PLANNING AND ZONING BOARD STAFF REPORT

109 SE 5th Avenue

Meeting	File No.	Application Type
January 26, 2026	2024-104	Level 3 Site Plan
Property Owner	109 5 th LLC	Authorized Agent

Consideration of a Level 3 Site Plan Application with Architectural Elevations and Landscape Plan for a four-story, approximately 98,000 square foot, 26-unit multi-family residential development.

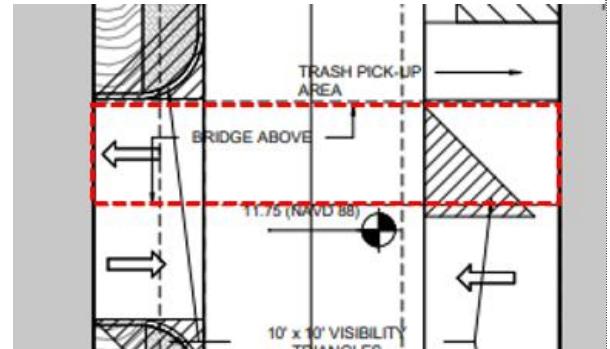
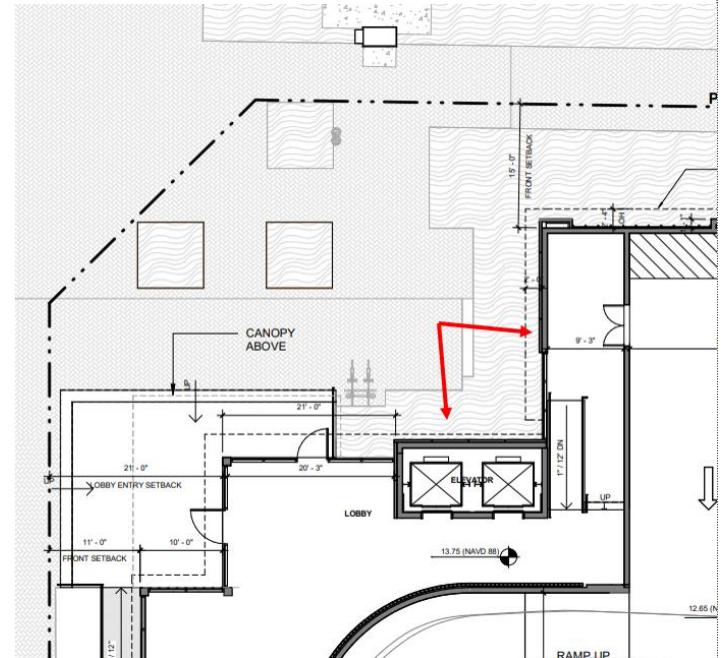
That being said, there are issues with the execution of the ground floor design that are detrimental to the quality of the public realm. Specifically, there is absence of a quality active use on the ground floor adjacent to the required civic open space at the NW corner. Principles of urban design require that for public spaces to be utilized to their fullest potential, it is essential that these spaces are lined with active uses within the adjacent structures so that there is an integration between the public realm and private space, where activity is naturally drawn through the public space which encourages further use, and to reinforce the idea of “eyes on the street” which facilitates safer and more vibrant public environments. LDR Section 4.4.13(G) provides specific regulations to ensure the civic space is presented with appropriate qualitative and schematic characteristics to achieve the desired outcome.

The applicant proposes a problematic ground floor configuration that undermines the purpose of the civic space and is inconsistent with quality urban design. The schematic choices are entirely avoidable, and despite Staff raising concerns from the initial review of this application, the Applicant has been reluctant to make modifications to the ground floor orientation and use-mix to help alleviate these crucial shortcomings.

Rather than lining the civic space with prominent and active uses, the building orients passive elements of the structure – such as the elevator stack and a secondary corridor that leads to the parking area – which are ill-suited to achieve the level of activity generation necessary for high quality public spaces. Best-in-class versions of public space will be lined by residential unit entrances; lobbies with multiple points of ingress/egress; commercial uses such as retail, café, and restaurant; or amenities that can function as gathering places, such as shared workspaces, coffee shops, etc. These types of uses accentuate the urban form by catalyzing the level of activity necessary to incentive use of the adjacent exterior space, as well as instill characteristics that strengthen the foundation of the neighborhood. Staff is concerned that, because of the lack of an active use liner, the required civic space will be an underutilized and inactivated aspect of the public realm.

Specifically, LDR Section 4.4.13(G)(3)(d) states that *Civic open spaces shall be lined by building facades or streets on all sides. In order to provide oversight of the space, buildings facing civic open spaces shall contain active uses.* While the required civic space is lined by extended lobby area, which technically may qualify as part of an active use (Main building lobby), the specific design and configuration of the portion of the lobby that lines the civic space is deficient for the reasons stated previously. Staff encourages the Board to consider whether the qualitative aspects of the ground floor design sufficiently meet the intent of the Central Business District, or if conditions that require revisions to the configuration to better address the referenced concern are appropriate.
